**ST. LUCIE PLANT  
UNIT 1 AND UNIT 2**

**IMPROVED TECHNICAL  
SPECIFICATIONS CONVERSION**

**ITS SECTION 3.4 REACTOR  
COOLANT SYSTEM (RCS)**

**Revision 0**

FIGURE 3.4-2a ← 3.4.3-1

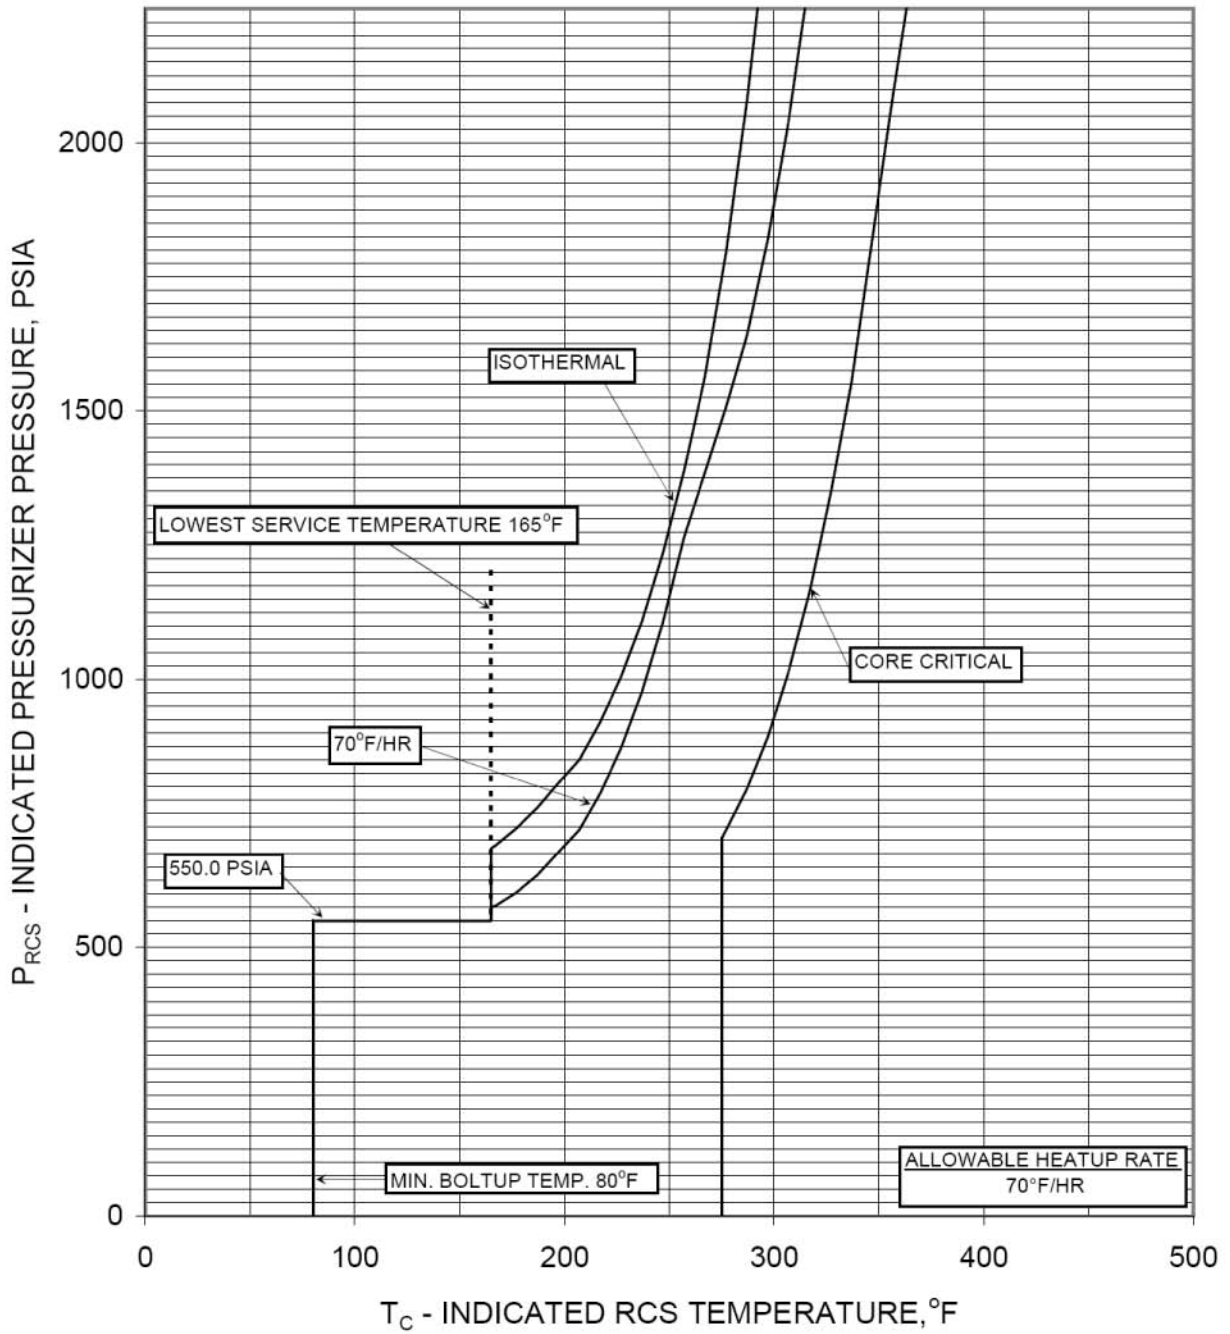
**ST. LUCIE UNIT 1 P/T LIMITS, 54 EFPY**  
**HEATUP AND CORE CRITICAL** ← ITY LIMITS

INSERT 1

Limiting Material: Lower Shell Axial Welds (Ht. #305424)

FIGURE 3.4-2b ← 3.4.3-2

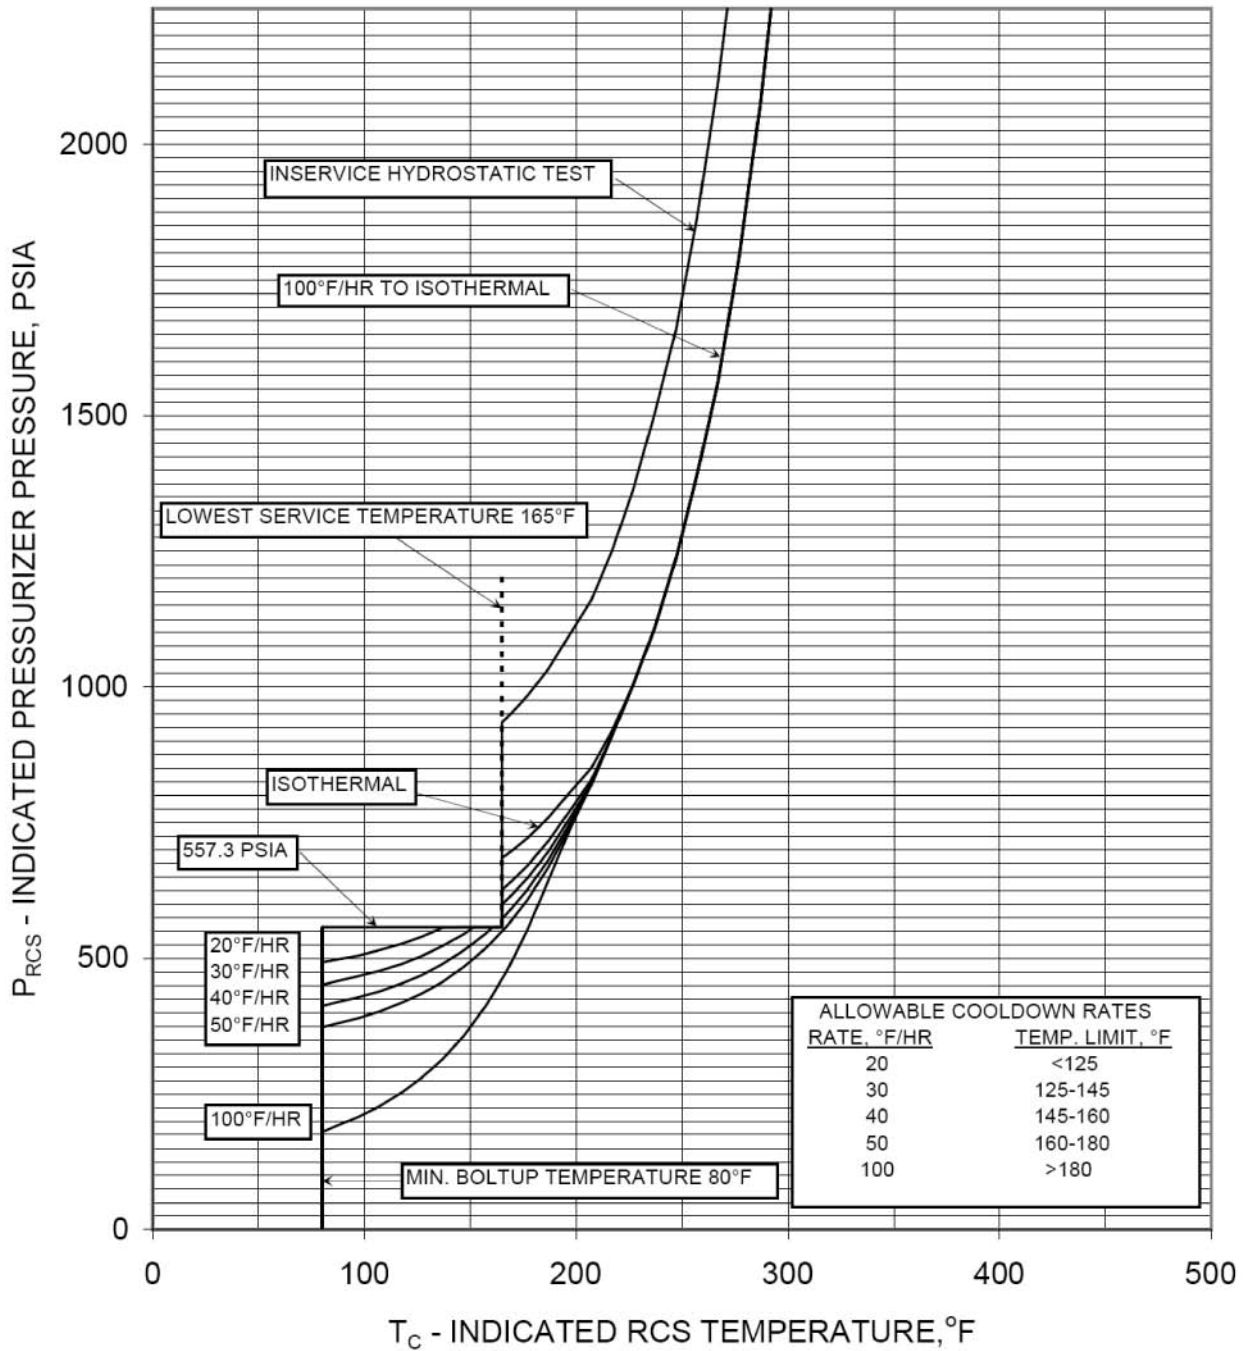
**ST. LUCIE UNIT 1 P/T LIMITS, 54 EFPY**  
**COOLDOWN AND INSERVICE TEST** ← LIMITS

INSERT 1

Limiting Material: Lower Shell Axial Welds (Ht. #305424)  
 Limiting ART Values at 54 EFPY: 1/4T, 210°F  
 3/4T, 156°F

FIGURE 3.4-2 ← 3.4.3-1

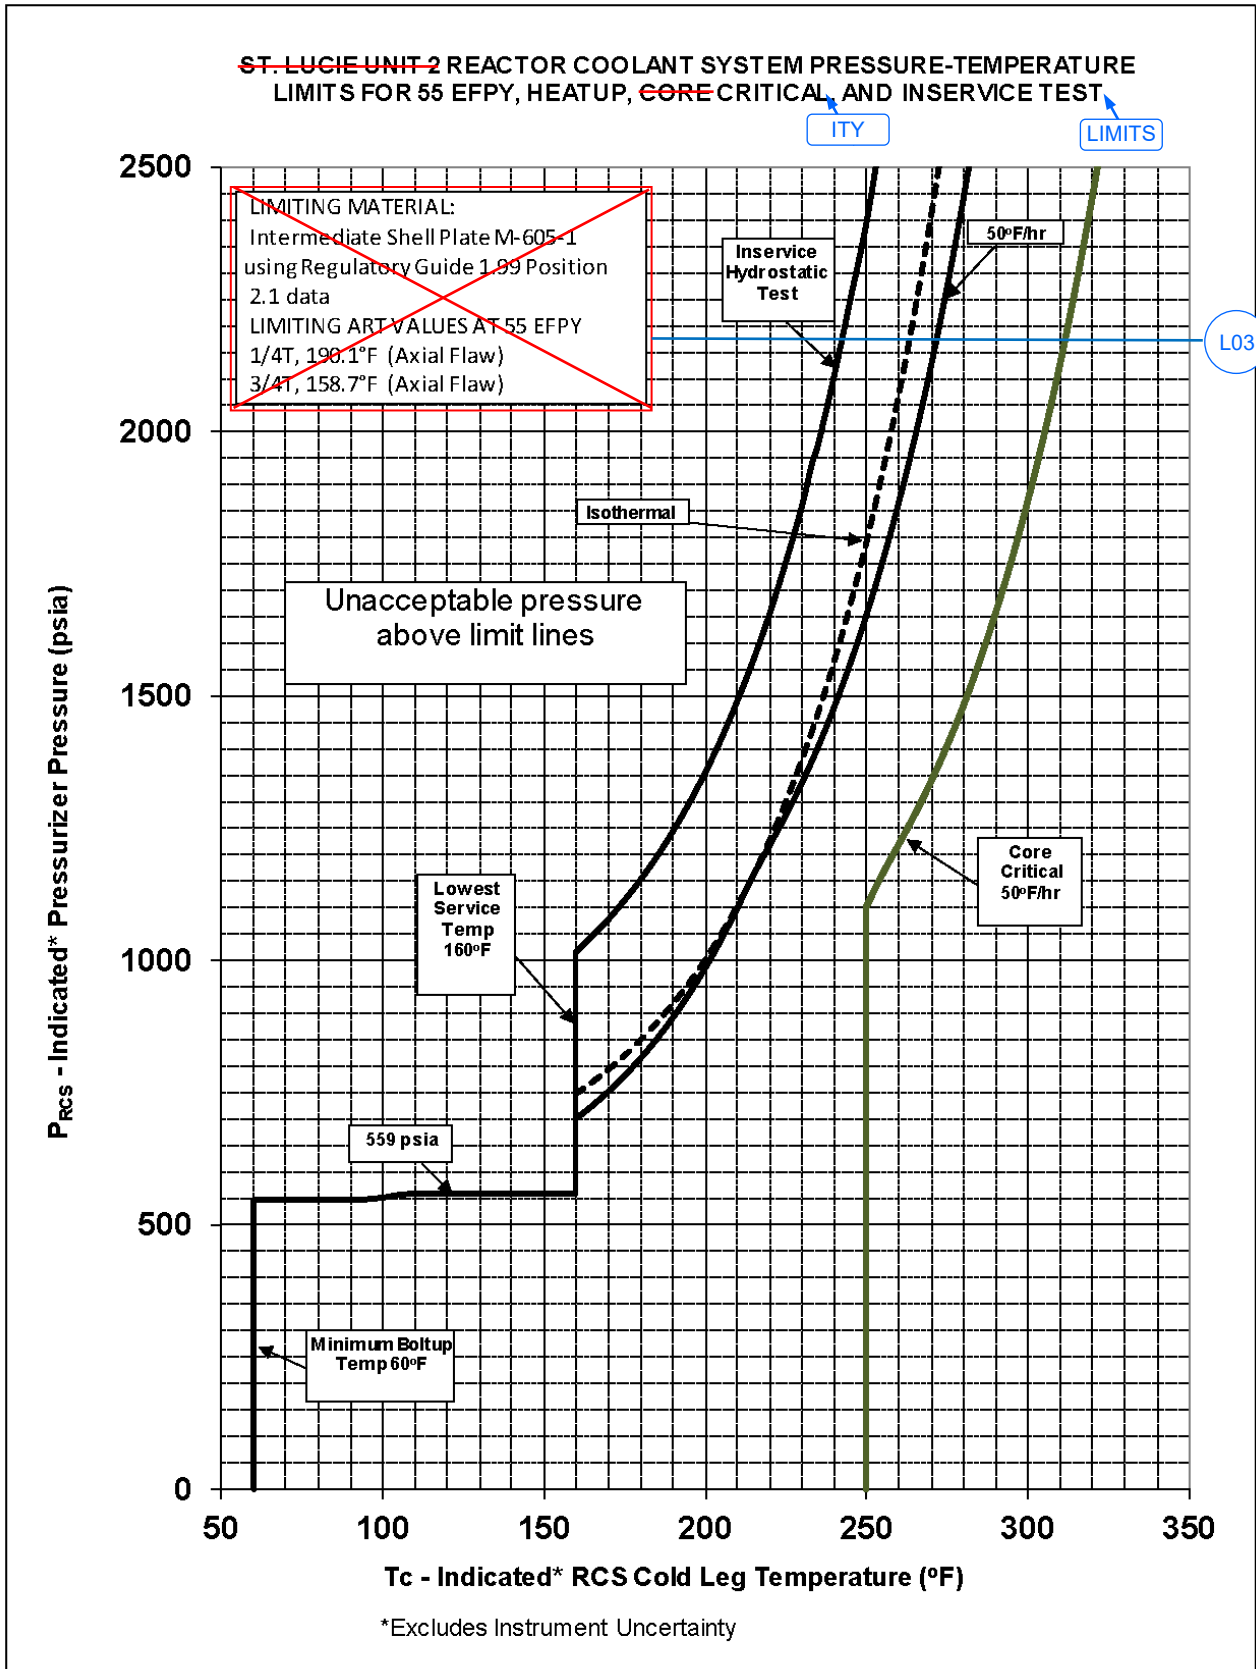
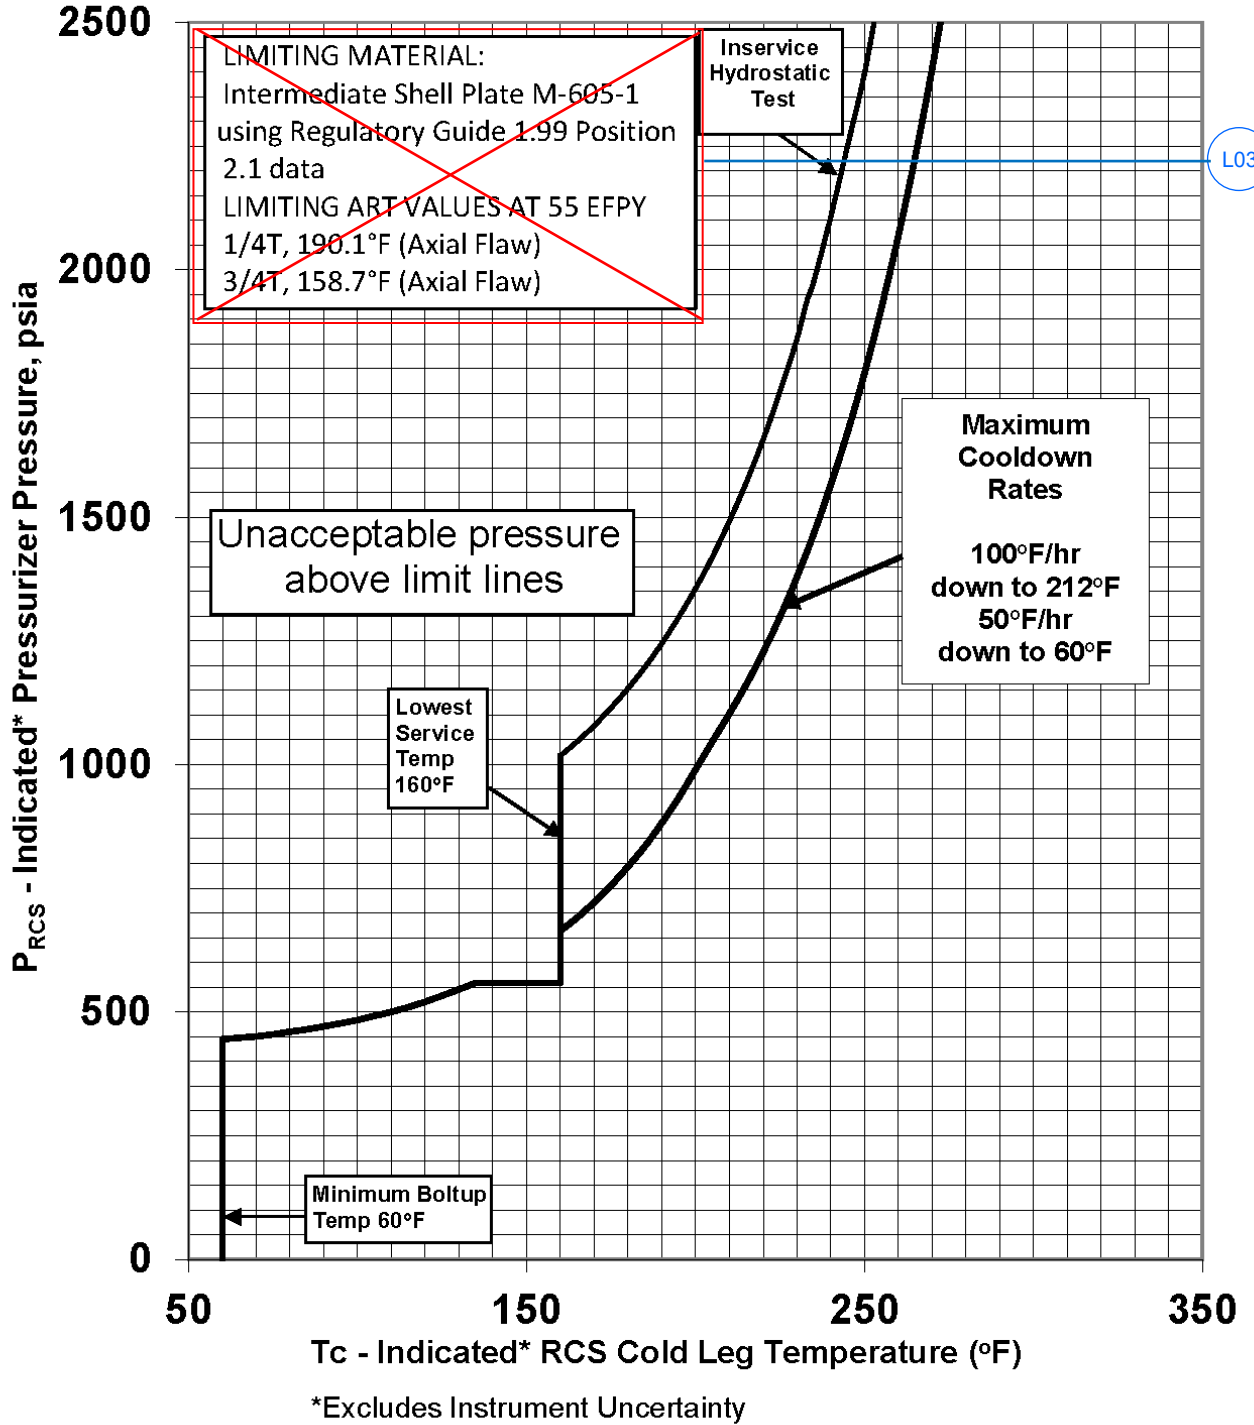
INSERT 1

~~ST. LUCIE UNIT 2 REACTOR COOLANT SYSTEM PRESSURE-TEMPERATURE LIMITS FOR 55 EFPY, COOLDOWN AND INSERVICE TEST~~

Figure 3.4.3-1  
Reactor Coolant System Pressure versus Temperature Limits -  
Heatup and Criticality Limits  
(54 EFPY)

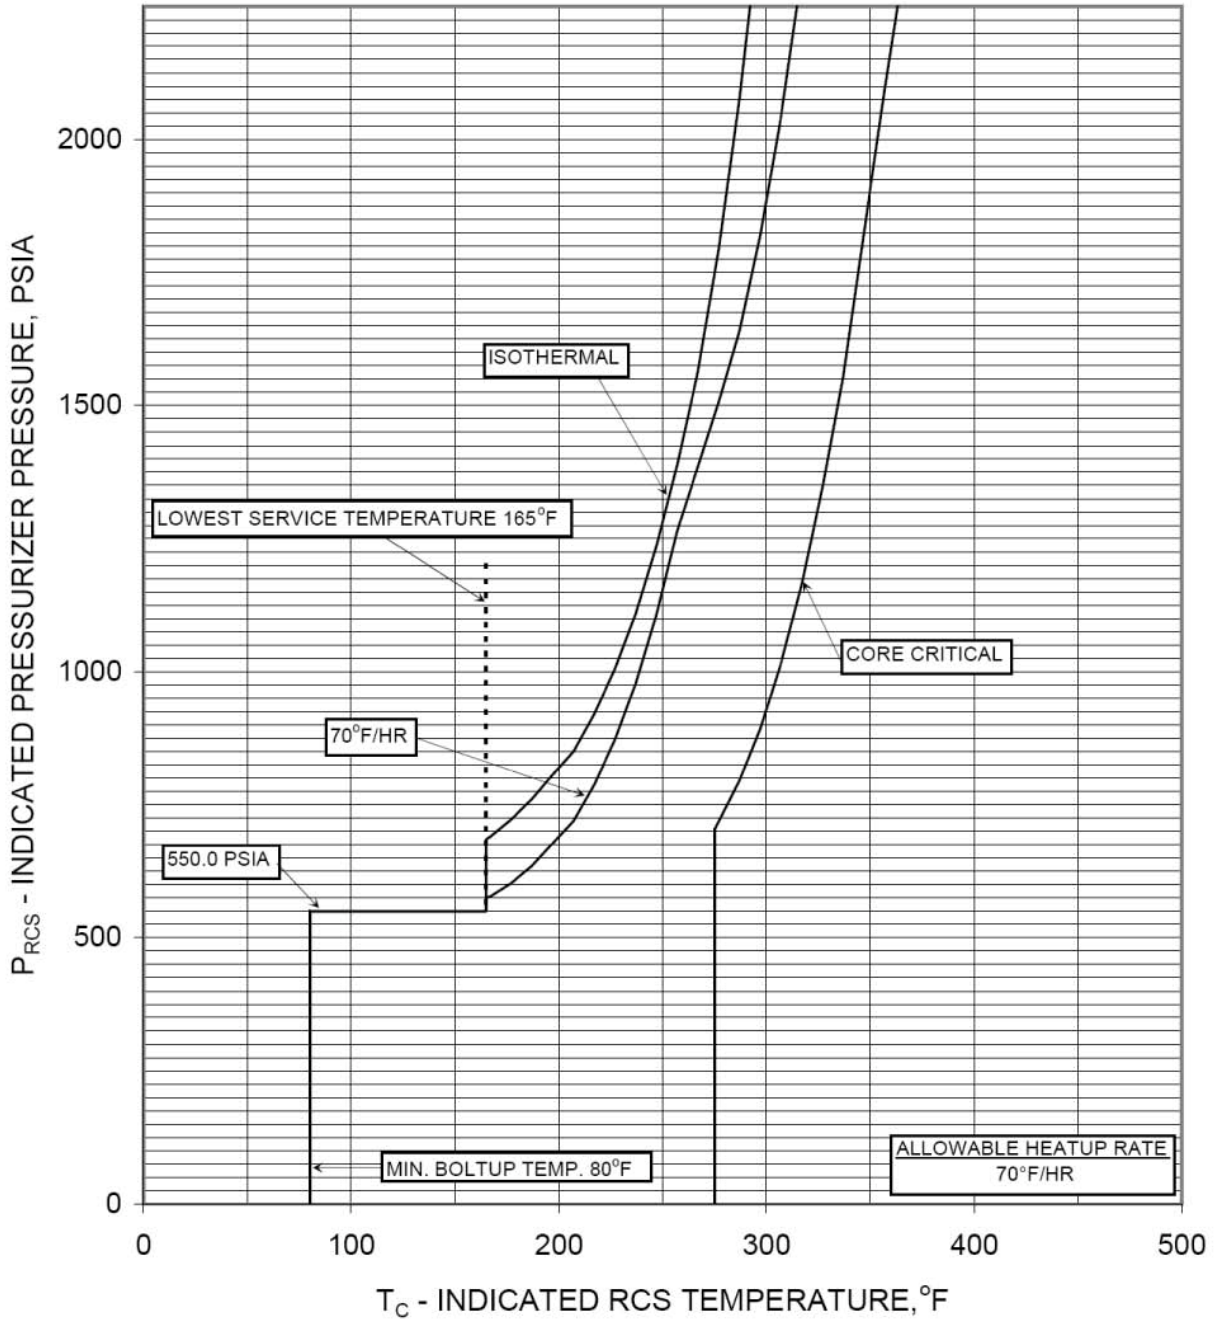
CTS Figure  
3.4-2a

3. PSL is not adopting a Pressure Temperature Limits Report (PTLR) and is retaining the RCS Pressure and Temperature (P/T) limits in the ITS. Therefore, references to the PTLR have been changed to Figures 3.4.3-1 and 3.4.3-2. In addition, the CTS P/T figures have been added to ITS 3.4.3 as Figures 3.4.3-1 and 3.4.3-2.

Figure 3.4.3-2  
Reactor Coolant System Pressure versus Temperature Limits -  
Cooldown and Inservice Test Limits  
(54 EFPY)

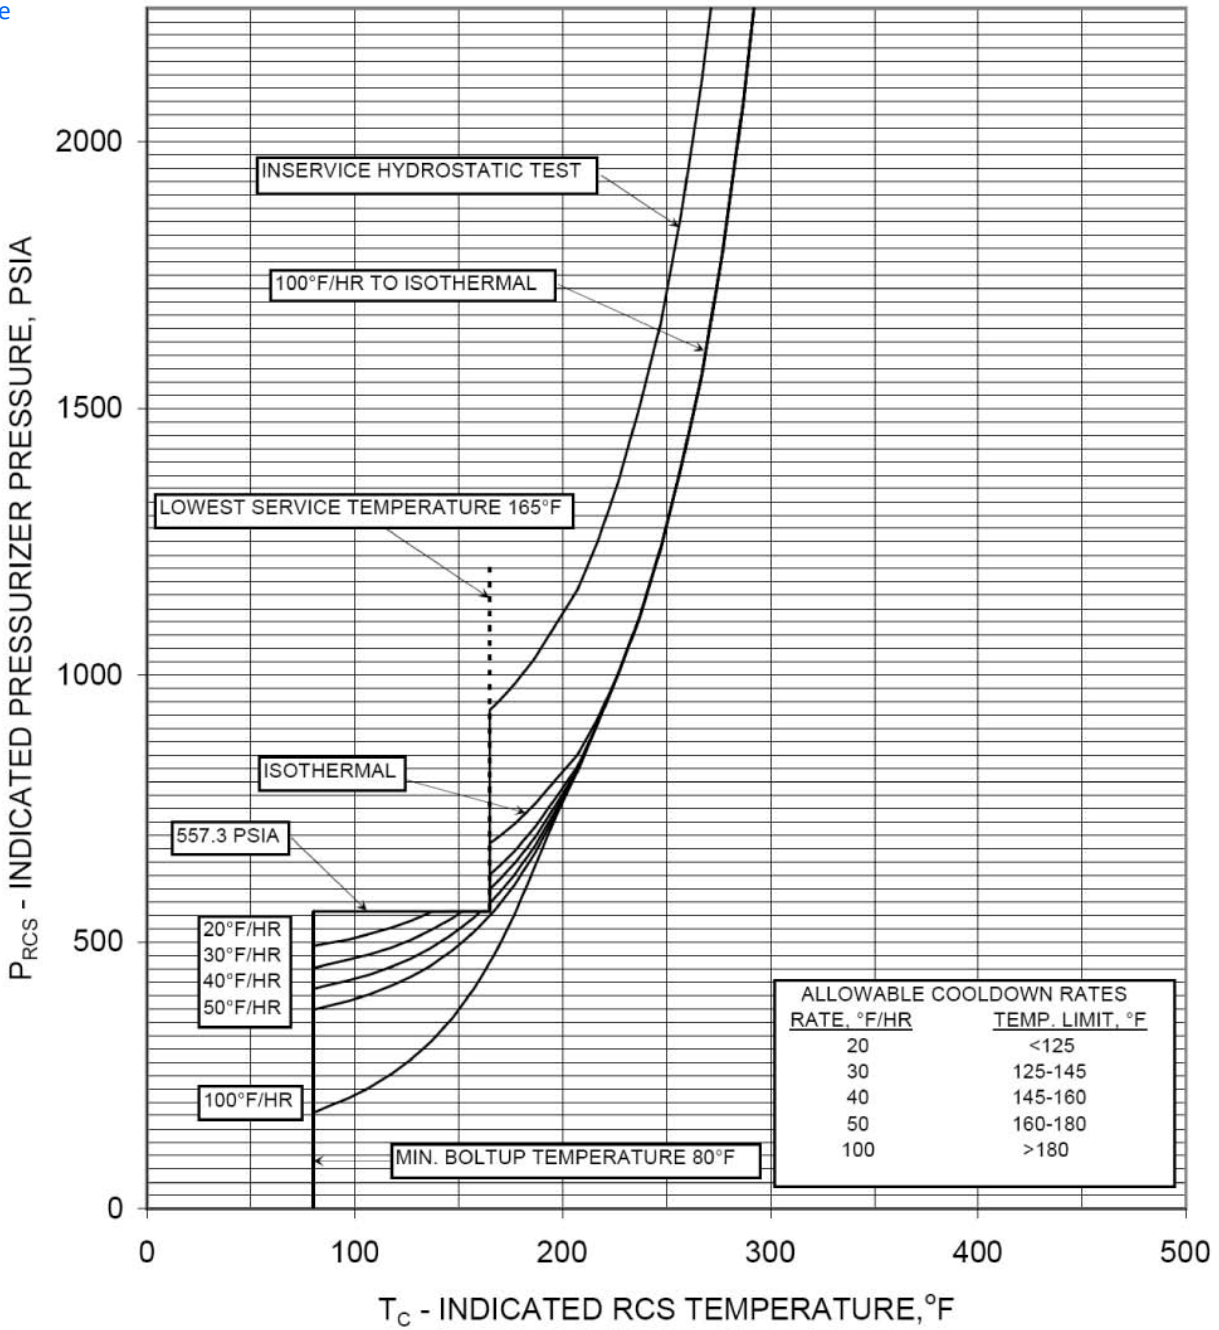
CTS Figure  
3.4-2b
